ARIZONA DEPARTMENT OF ENVIRONMENTAL QUALITY

**RESPONSIVENESS SUMMARY
TO
PUBLIC COMMENTS AND QUESTIONS**

**Energy Fuels Resources (USA) Inc. – Pinyon Plain Mine
Permit # 88788**

October 20, 2021

Figure 1: Learning Site Evaluation for Pinyon Plain Mine

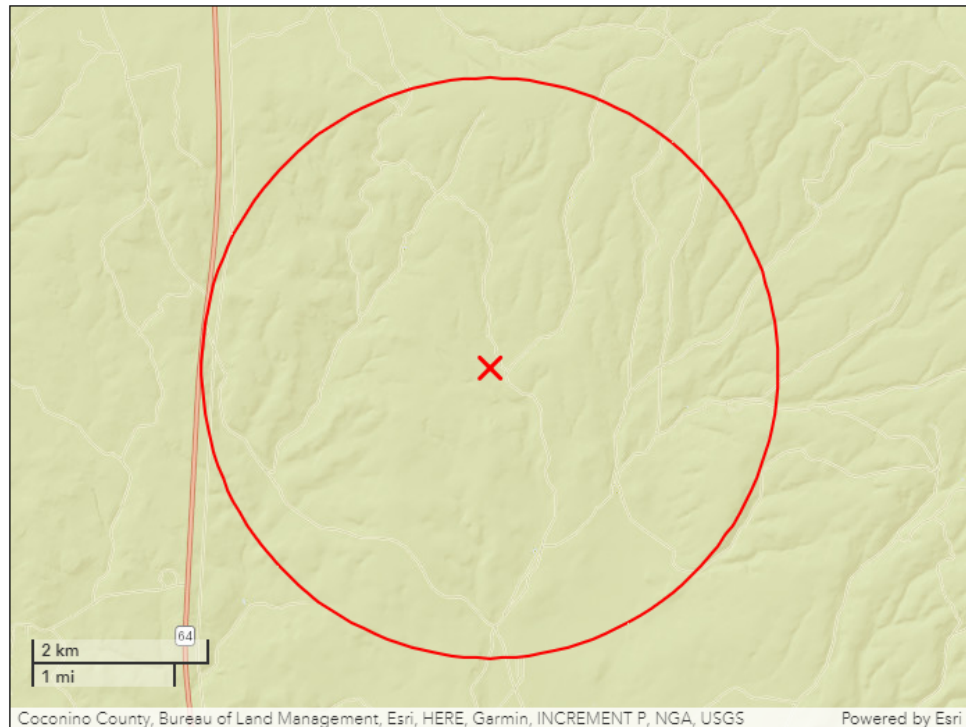
Comment 46: The commenter requests that ADEQ conduct a learning site evaluation for the community surrounding the Pinyon Plain mine. Additionally, the commenter requests that ADEQ conduct a learning site evaluation to demonstrate that the impacts from the facility won't adversely impact the surrounding community.
See Commenter: 3

For Class II Permits, the ADEQ Learning Site Policy requires that an evaluation be conducted for new permits and for revisions that increase criteria pollutants greater than the permitting exemption thresholds. According to the policy, "[p]ermit renewals without any associated modifications are exempt from the learning sites policy on the basis that they are existing facilities which have no new emissions and will be addressed as part of any future modification which results in an emissions increase greater than the permitting exemption threshold." Thus, based on the policy and the renewal application, there was no requirement to conduct a learning site evaluation for this permitting action.

The Department conducted a Learning Site Evaluation in response to this concern. By definition learning sites “consist of all existing public schools, charter schools and private schools at the K-12 level, and all planned sites for schools approved by the Arizona School Facilities Board.” Using the Arc GIS tool, it was determined that there are no learning sites are within 2 miles of the facility. This can be seen in Figure 1 above.
